Office Action Summary	Application No.		Applicant(s)	
	10/663,995		LEE ET AL.	
	Examiner		Art Unit	
	Stephen Gravini		3749

DETAILED ACTION

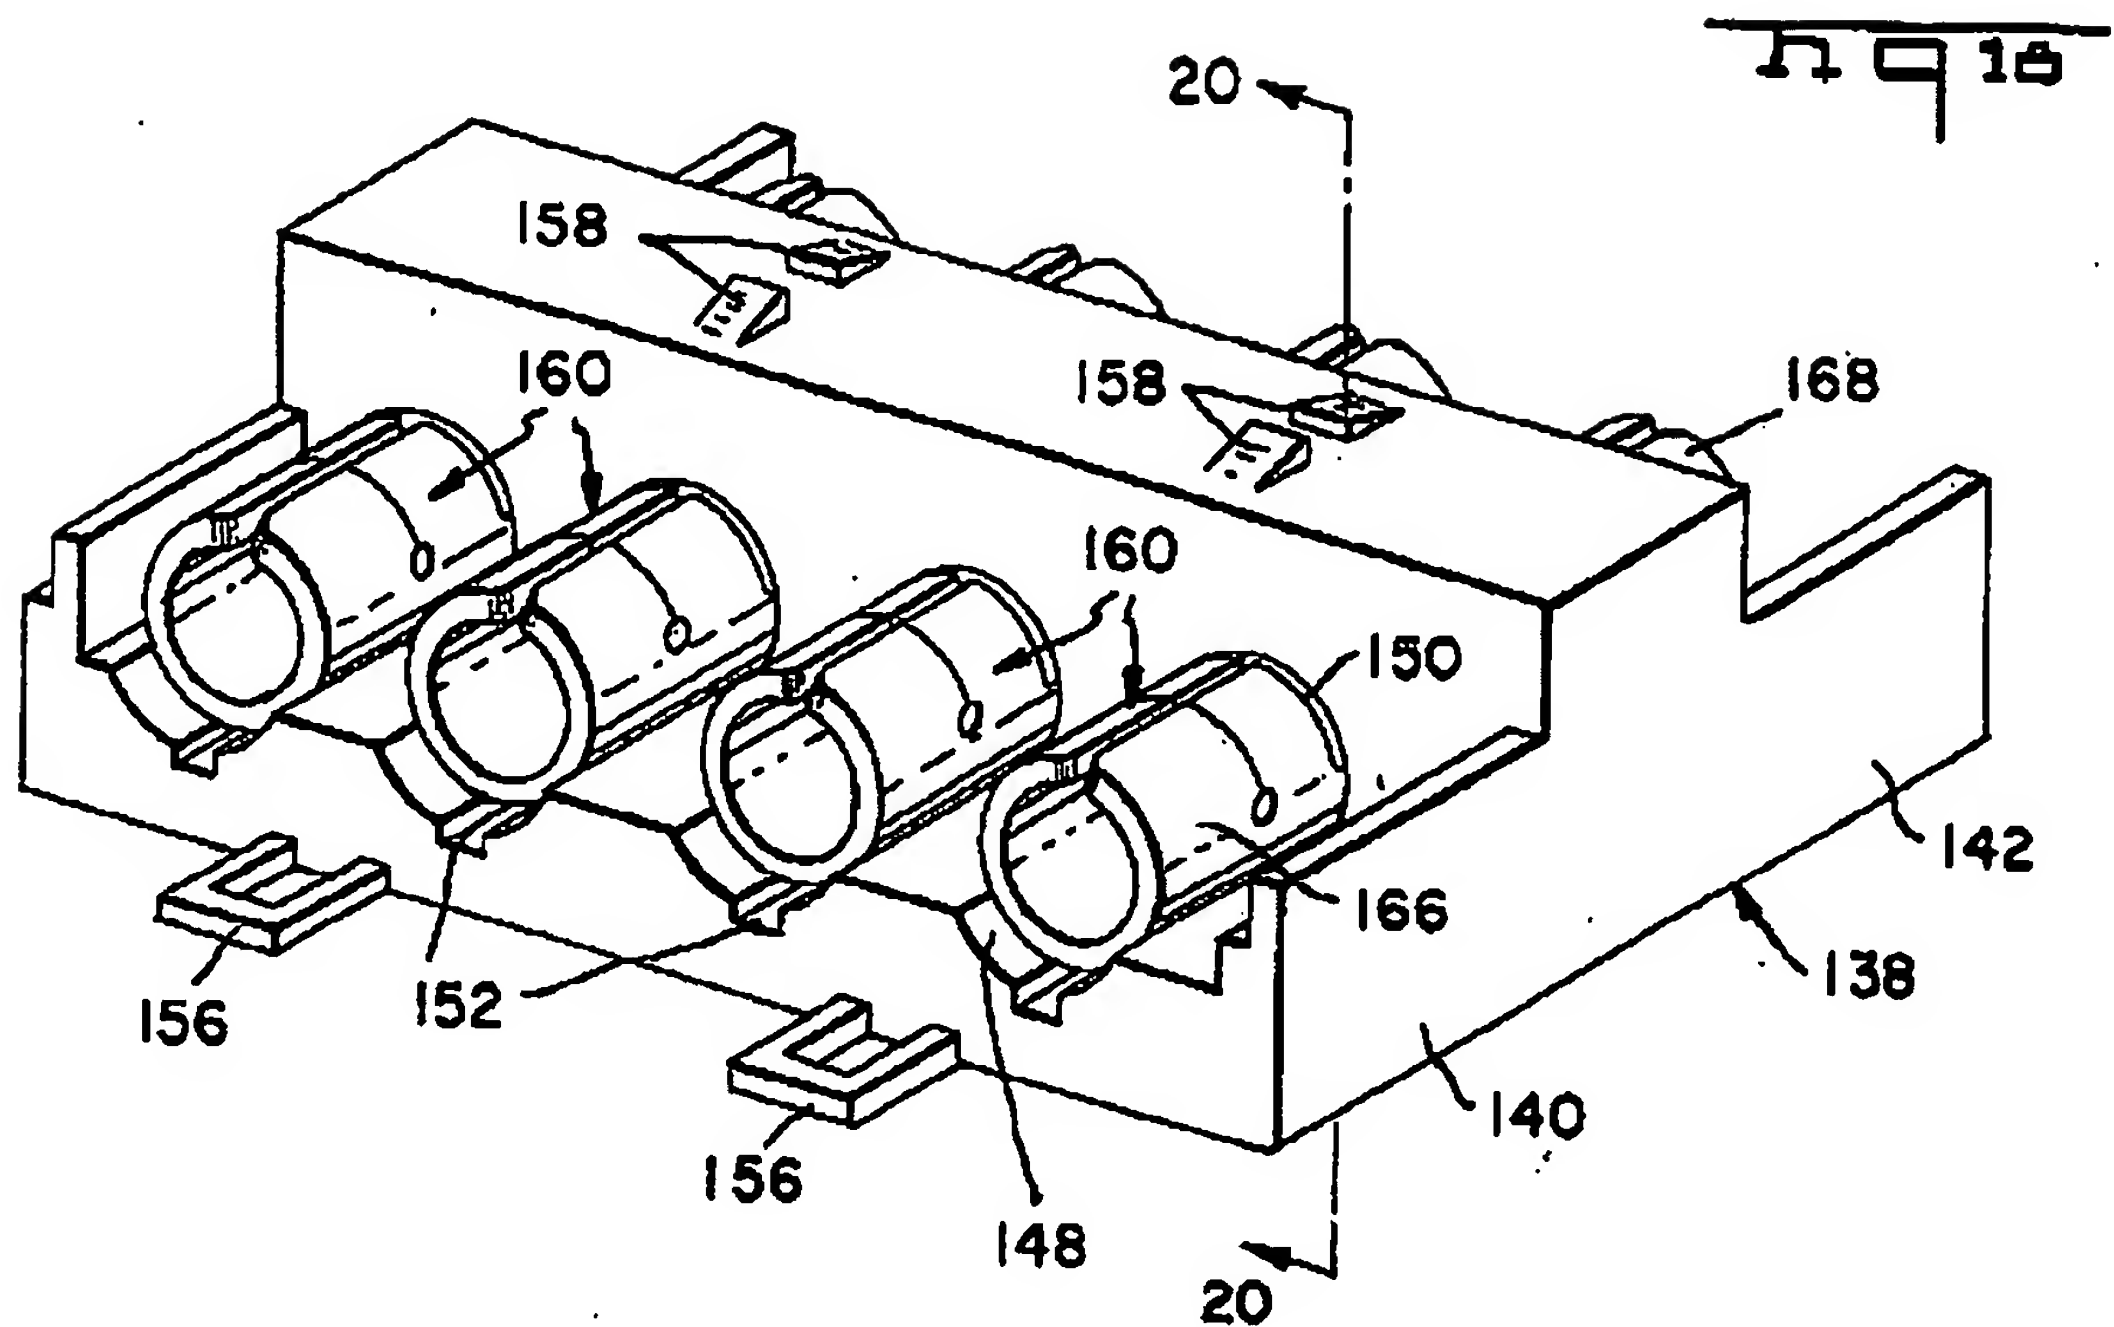
a terminal block **138** disposed within the laundry dryer control panel, the terminal block having a lower part **140** and an upper part **142**;

a wall extending from the terminal block lower part and the terminal block upper part (please see figure **18** reproduced below wherein the raised portion surrounding reference character **166** and above reference character **142** is considered to anticipate the claimed wall because both extend from a terminal upper and lower part respectively);

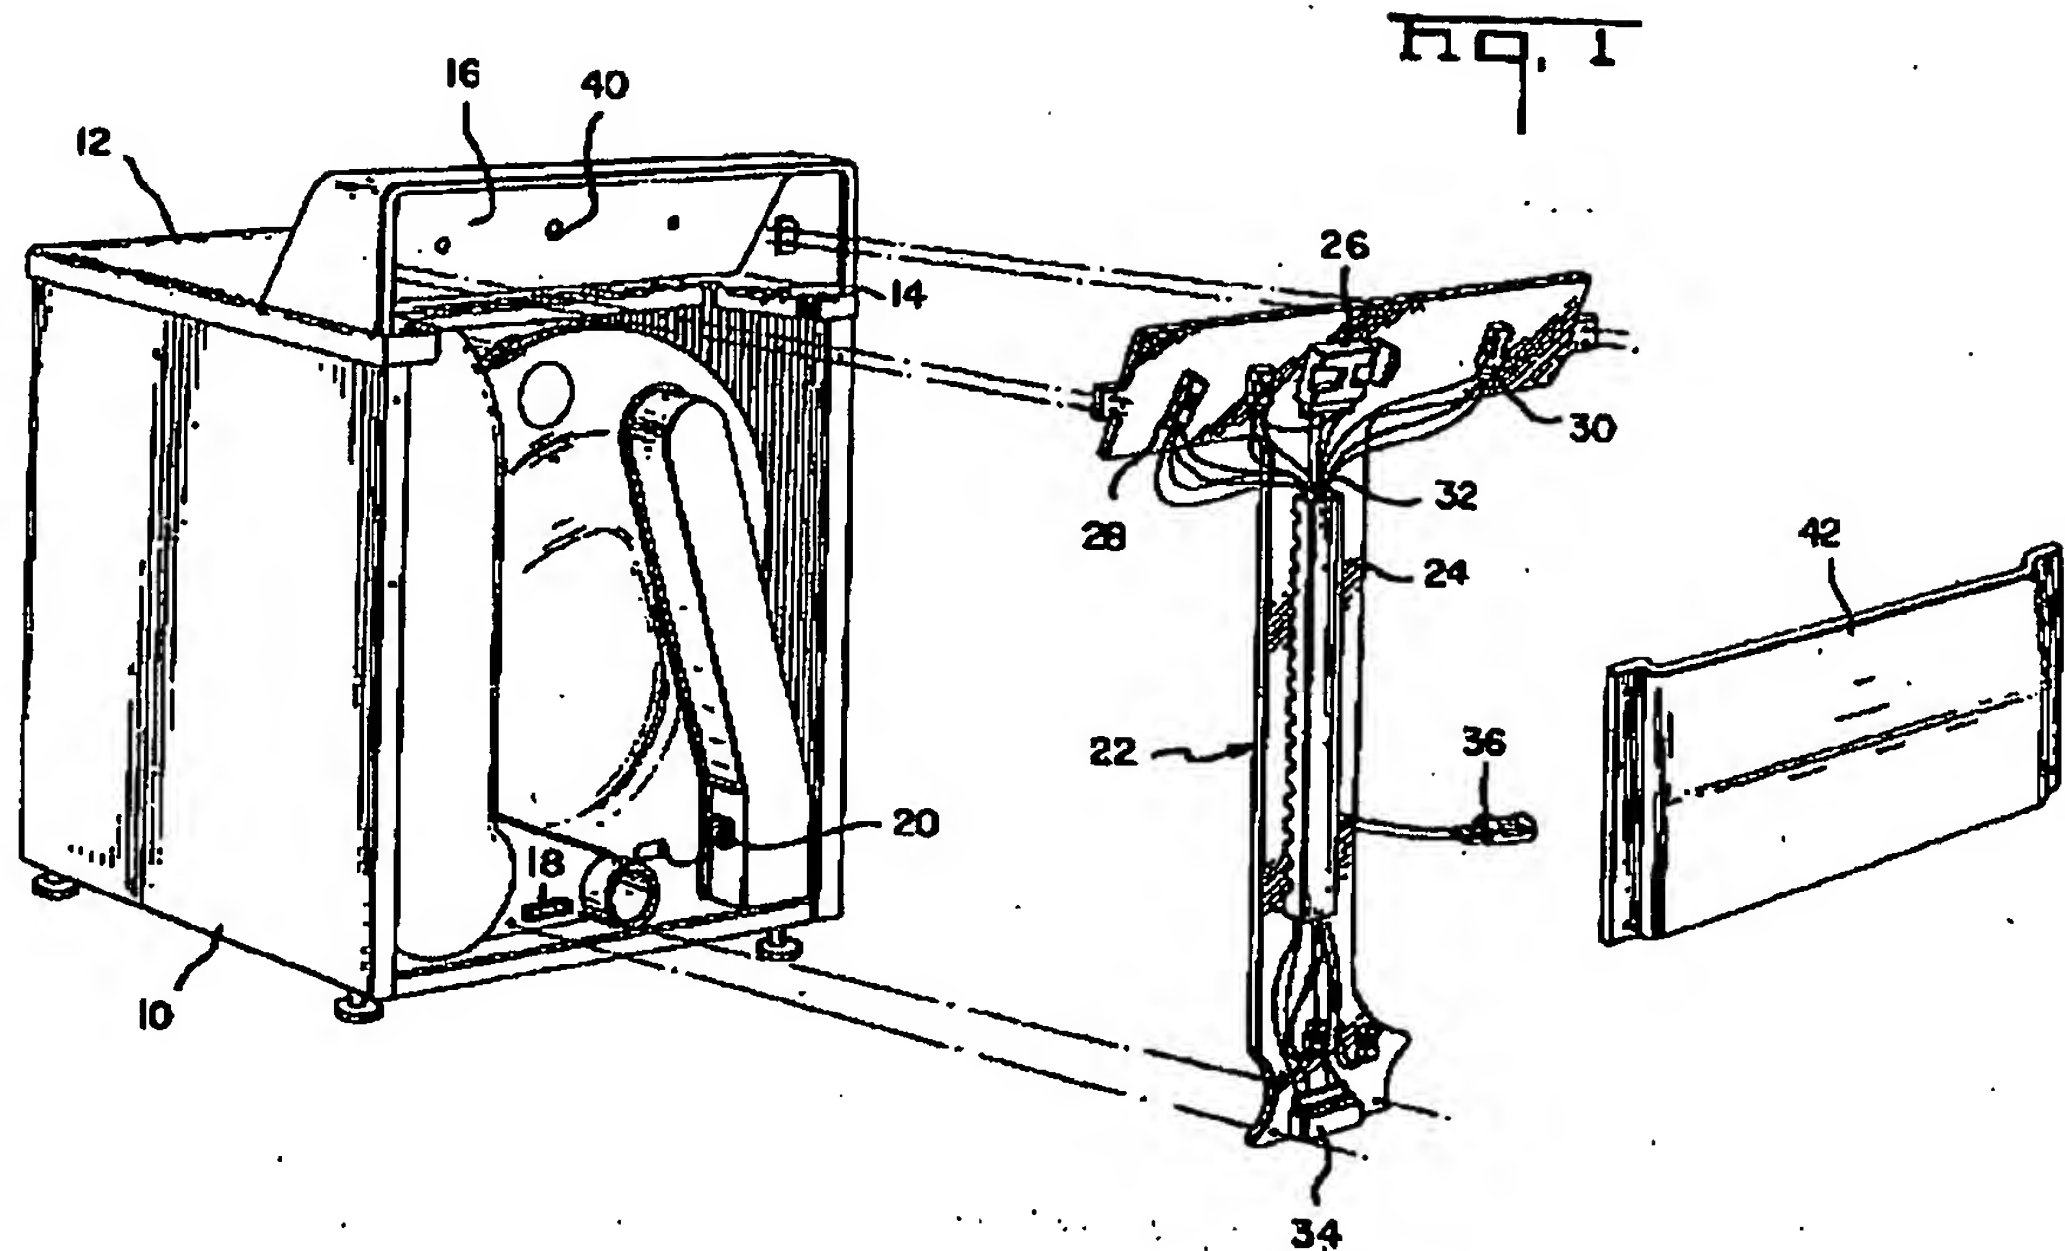
- a control panel **217** provided on a rear portion of the top cover. McCormick is considered to disclose the claimed invention except for the claimed back cover forming a back side of the clothes dryer, terminal block provided on an inside of the control panel, a wall for shielding an exposed part of core wire extending from an upper front portion and lower front portion of the terminal block including a single body terminal block formation. Hopkins, another structure for a clothes dryer, is considered to disclose a back cover **42** in figure 1 (shown below),
